PRODUCT / PROCESS CHANGE NOTIFICATION

PCN#2609009-AU • DATE: 23rd September, 2026

PCN Subject: Additional Assembly Site for SOT-323 Series Automotive Products

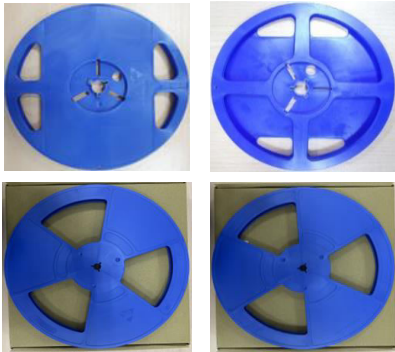
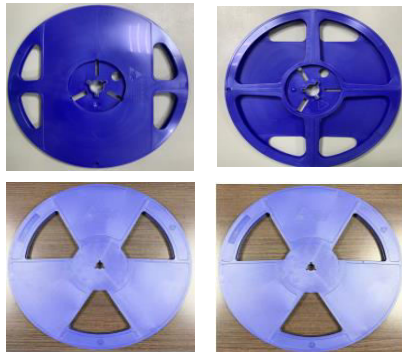
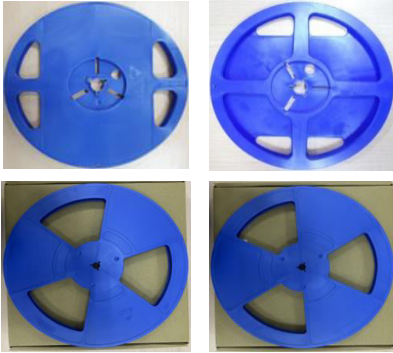
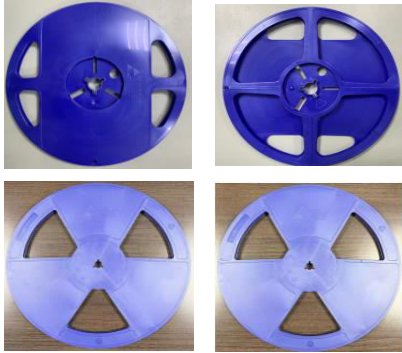
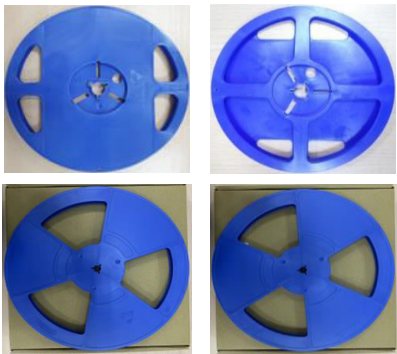
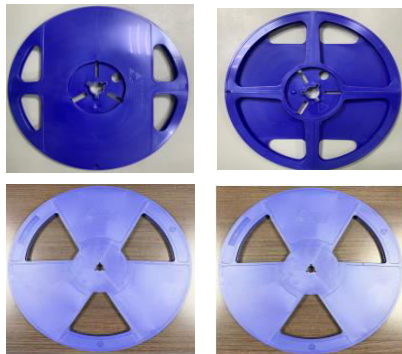
Comparison			Table 1	
			Current	Add
Assembly Site			PANJIT International Inc.	PANJIT Semiconductor (Xuzhou) Co., Ltd.
Production Site Location			Kaohsiung, Taiwan	Xuzhou, China
Package			SOT-323	
Material	Lead Frame	Material	Alloy 42	Copper
	Die Attach	Process	Eutectic	
	Wire	Material / Diameter	Cu / 1.0mil	
	Epoxy Molding Compound	Product Name	ELER-8-500C	KHG500
	Ending Tape	Material	Polyester	Paper
		Color	Black	Yellow
	Plastic Reel			
Form	Marking Format			
			Add bar "-" for new assembly site

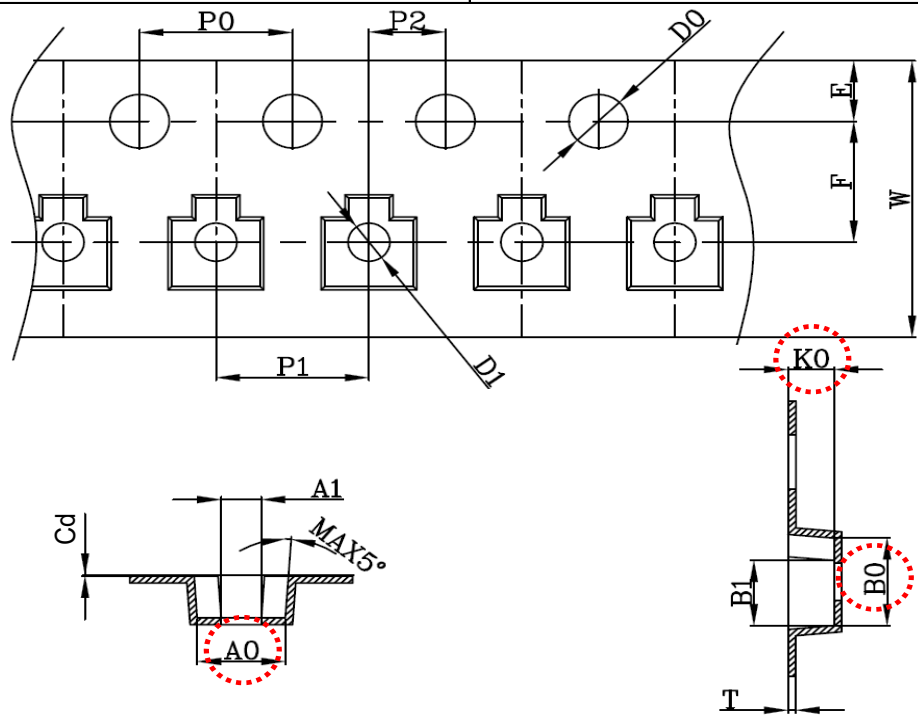
Comparison			Table 2	
			Current	Add
Assembly Site			PANJIT International Inc.	PANJIT Semiconductor (Xuzhou) Co., Ltd.
Production Site Location			Kaohsiung, Taiwan	Xuzhou, China
Package			SOT-323	
Material	Wafer	Supplier	Phenittec semiconductor Corp.	Jiangsu Xinshun Microelectronics Co., Ltd.
		Die size(mil)	10.2x10.2 11x11 11x11 13x13 13.8x13.8 15.7x15.7 16.1x16.1	11.02*11.02 9*9 11.02*11.02 13.8*13.8 13.8*13.8 17.3*17.3 11.02*11.02
	Lead Frame	Material	Alloy 42	Copper
	Die Attach	Process	Eutectic	
	Wire	Material / Diameter	Ag / 1.0mil Au / 1.0mil Cu / 1.0mil	Cu / 0.8mil Cu / 0.8mil Cu / 1.0mil
	Epoxy Molding Compound	Product Name	ELER-8-500C	KHG500
	Ending Tape	Material	Polyester	Paper
		Color	Black	Yellow
	Plastic Reel			
	Form

Add bar "-" for new assembly site
